PIC16C62

PIC16C62 Rev. A Silicon Errata Sheet

The PIC16C62 (Rev. A) parts you have received conform functionally to the Device Data Sheet (DS30234D), except for the anomalies described below.

FIGURE 1: WRITES TO TIMER1 (EXTERNAL CLOCK / OSCILLATOR MODE)

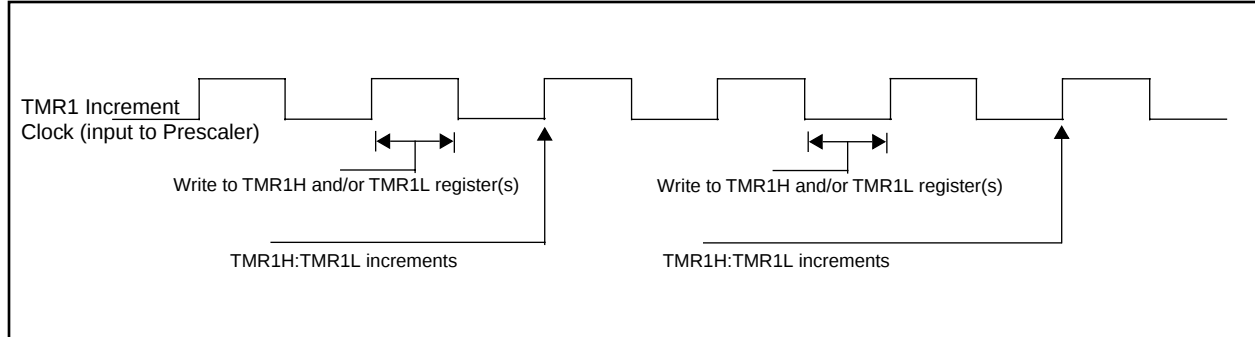
- a) The operation of Timer1 needs some clarification when the timer registers are written when the TMR1ON bit is set.
- The internal clock signal that is the input to the TMR1 prescaler affects the incrementing of Timer1 (TMR1H:TMR1L registers and the Timer1 prescaler). When the Timer1 registers are NOT written, the Timer1 will increment on the rising edge of the TMR1 increment clock.

When the TMR1H and/or TMR1L registers are written while this clock is high, TMR1 will increment on the next rising edge of this clock.

When the TMR1H and/or TMR1L registers are written while this clock is low, TMR1 will not increment on the next rising edge of this clock, but must first have a falling clock and the the rising clock for TMR1 to increment.

Figure 1 shows the two cases of writes to the TMR1H and/or TMR1L registers. Due to the V_{IH} and V_{IL} thresholds on the oscillator/clock pins, external

Timer1 oscillator components, and external clock frequency, the Timer1 increment clock may not be of a 50% duty cycle.

The TMR1 increment clock is out of phase of the T1OSO/T1CKI pin by a small propagation delay.
